By email: unitaryplan@aucklandcouncil.govt.nz**Re: Submission on Plan Change 100 (PC100) to the Auckland Unitary Plan****Submitter:**

Submission on Proposed Plan Change 100 Auckland Unitary Plan (Operative in Part)

**SUBMISSION ON PRIVATE PLAN CHANGE 100 (RIVERHEAD) TO THE AUCKLAND UNITARY PLAN
(OPERATIVE IN PART)**

Figure 1: Existing site plan (site boundary shown by red line)

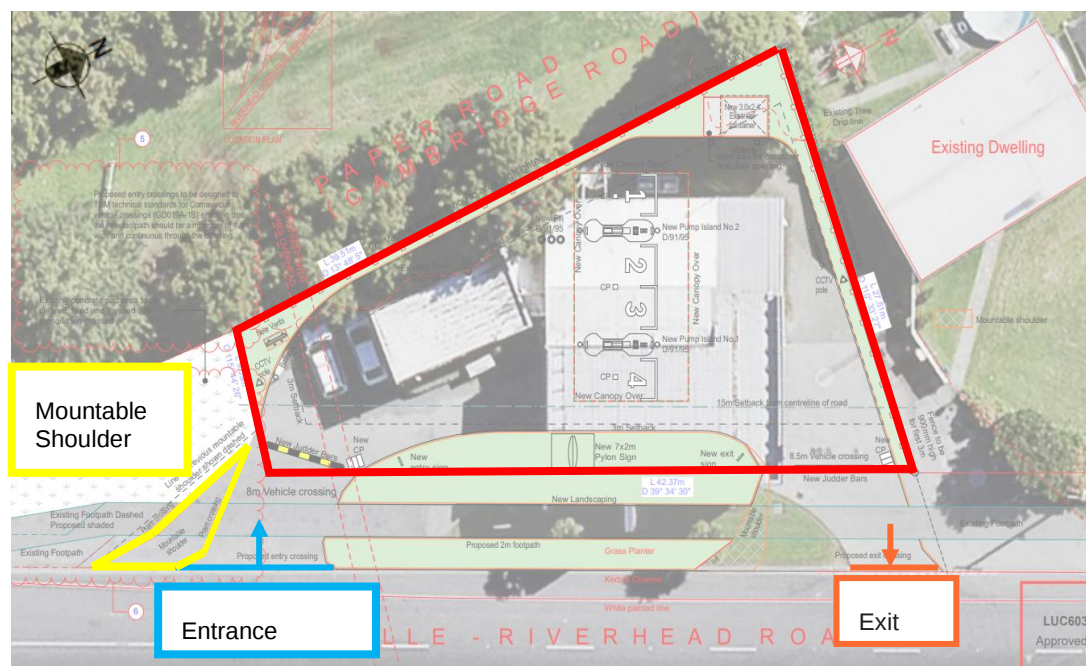
5. Caltex Riverhead was recently redeveloped as a service station having obtained resource consent in 2022 (LUC60392331 & DIS60398679). It is served by two existing crossings along the Coatesville-Riverhead Highway frontage, which tankers and customers use on a frequent basis. A mountable shoulder is positioned near the entrance crossing and extends over the property boundary, and this was approved by Auckland Transport as part of the resource consent to facilitate safe access for tankers entering the site. The site also has a building line restriction inside its front boundary. These site features are depicted in Figure 1 below. Z Energy seeks to ensure that these aspects of the site are not impacted by road changes proposed through PC100.

Figure 2: PC100 Proposed Road Upgrades

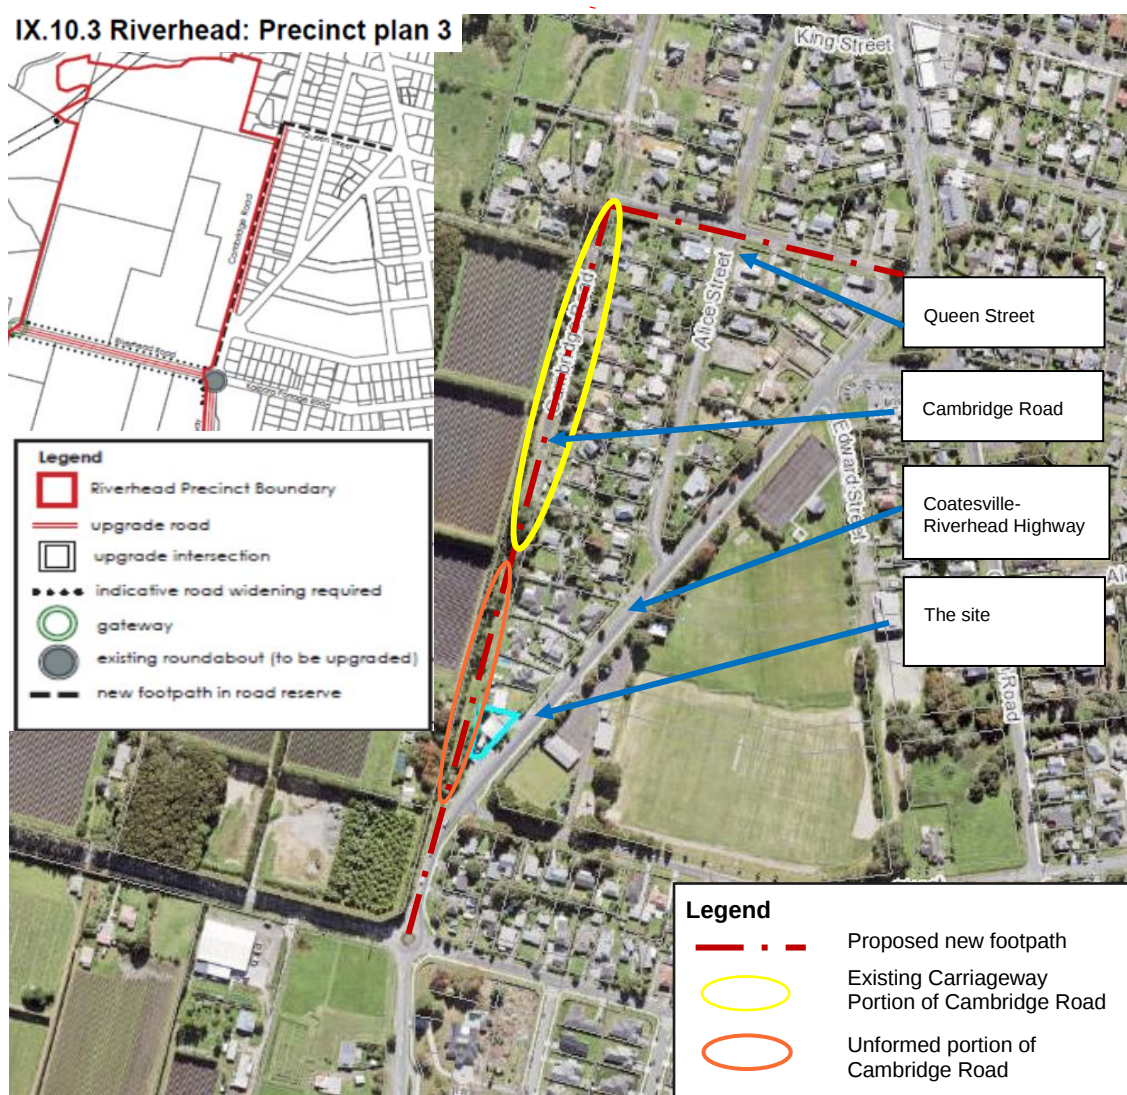
6. Standard IX.6.1(5) of the Proposed Riverhead Precinct Chapter requires that prior to occupation of a building on a site with vehicle access to and/or from Cambridge Road, (a) a new footpath shall be constructed on the western side of Cambridge Road between Queen Street and Riverhead Road, and (b) the existing carriageway of the formed portion of Cambridge Road shall be upgraded to an urban standard. Z Energy understands that the applicant's intention, consistent with these provisions, is to provide vehicle access for only the existing formed portion of Cambridge Road (to the north of Caltex Riverhead), with only a pedestrian footpath (no vehicle access) in the existing paper road portion of Cambridge Road next to Caltex Riverhead. Refer to Figure 2 below. Z Energy seeks confirmation regarding the road changes proposed through PC100, noting that Precinct Plan 3 indicates that there is potential for the entirety of Cambridge Road to be 'upgraded' (refer to Figure 2 below).

7. Z Energy supports the proposal for only a pedestrian footpath and no vehicle carriageway in the unformed portion of Cambridge Road next to Caltex Riverhead, if this is proposed as part of PC100. This arrangement ensures that vehicles can continue to safely enter the Caltex site, including via the mountable shoulder that sits outside its boundaries. If, on the other hand, a new vehicle carriageway was proposed at the Cambridge Road / Coatesville-Riverhead Highway intersection, this could

FIGURE 1: RIVERHEAD CORE RETAIL CATCHMENT

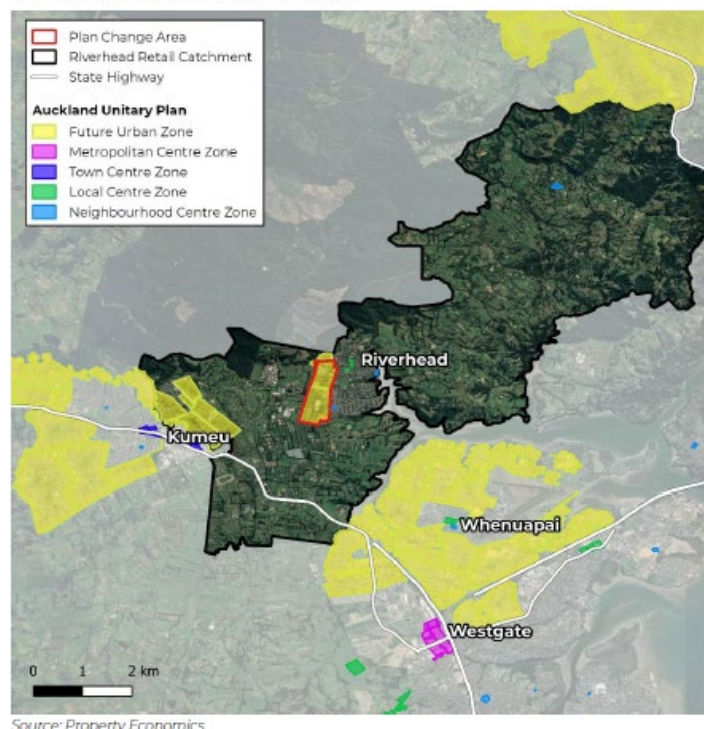
16. The basis for the proposed commercial zones is an economic report which predicts future demand (Appendix 7 – Centres Assessment). This report provides a cursory summary of the existing commercial activities and zoning. It also bases predicted demand on a 'Riverhead Core Retail Catchment'. The report provides no basis for the extent of this catchment despite it being a formative assumption. Astonishingly, the catchment extends and wraps around Kumeu and goes all the way to the Dairy Flat Highway.

17. Defining this as a catchment for Riverhead as a retail destination is ridiculous at both extents of the area shown. People in the Kumeu area have no incentive to travel to Riverhead for shopping. Kumeu is well served with a supermarket and a huge range of retail and commercial services. Council's own consultation documents for Kumeu show the extensive land at Kumeu dedicated for these activities.

Agree with comments on page 22 of community input - Appendix 18

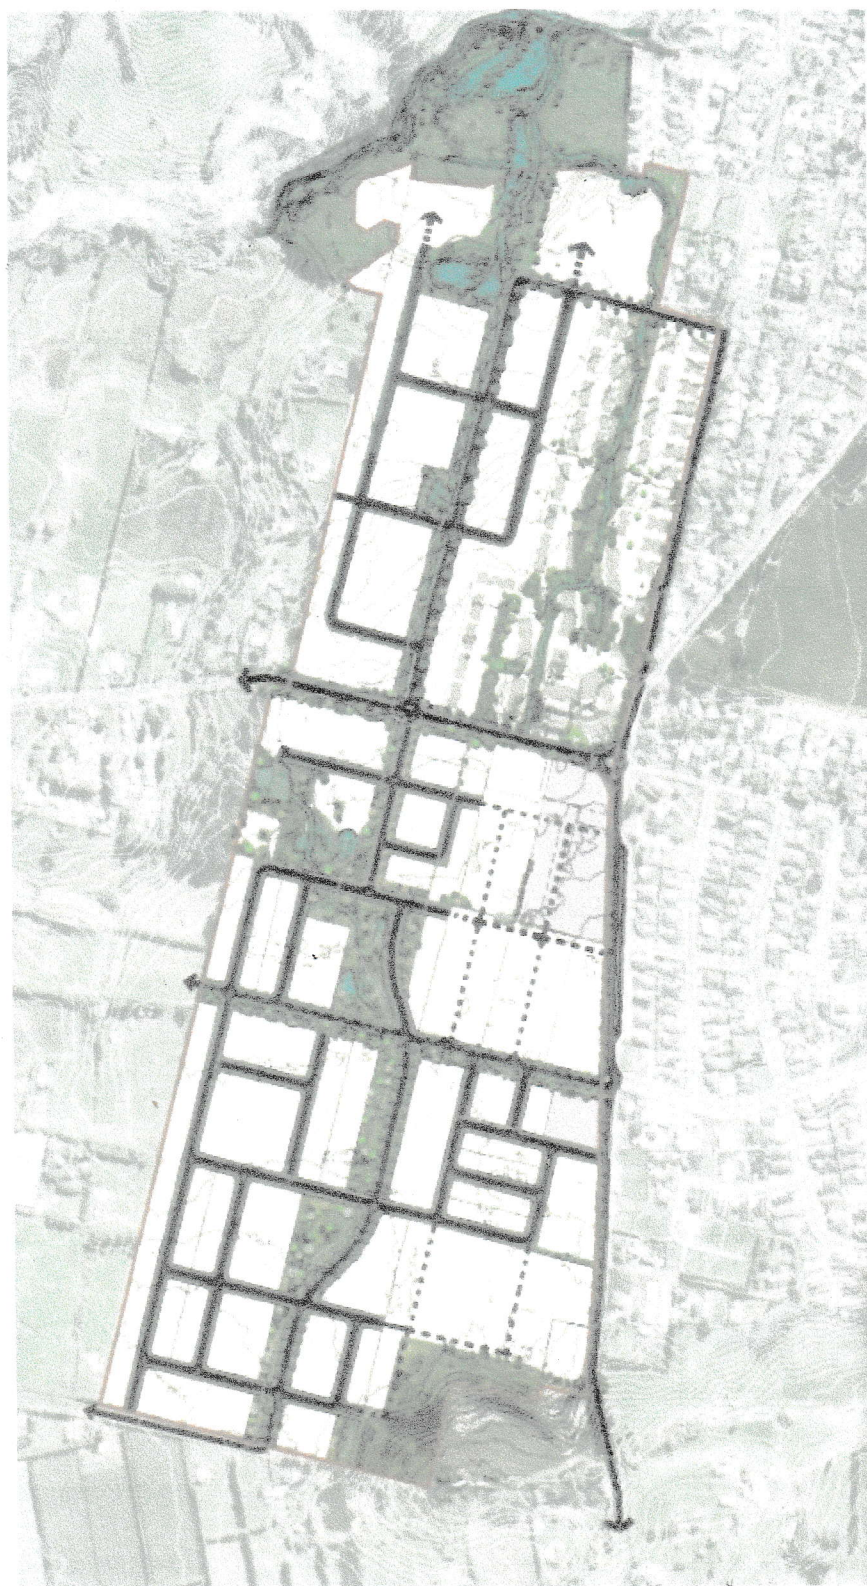
Having read the PPC 100 Riverhead Community Association Submission Final response document I support every point made and the suggested solutions. The other things that thoroughly irks me is the THAB's that brings with it the associated intensification - THIS IS NOT RIVERHEAD. I don't recall any information that clarifies whether the Apartments and Terraced units will have off-street garaging for all the occupiers, if not you can imagine how clogged the streets will be, starting to look like Avondale!! The Parks areas don't look like Parks but more like "Small Greens" the size of a postage stamp, no quality offered there. The green corridor running through offers nothing other

than the appearance of a covered stormwater drain, to call it multi-purpose is a gross exaggeration, surely the design team can be more imaginative. The Plan Change and the proposed housing needs to be clarified more about how high the Apartments will be, is it 3 stories or 6 stories??? And again what about Apartment and THAB Occupiers garaging of their vehicles. The Neighbourhood Centre location looks weird - out on its own.
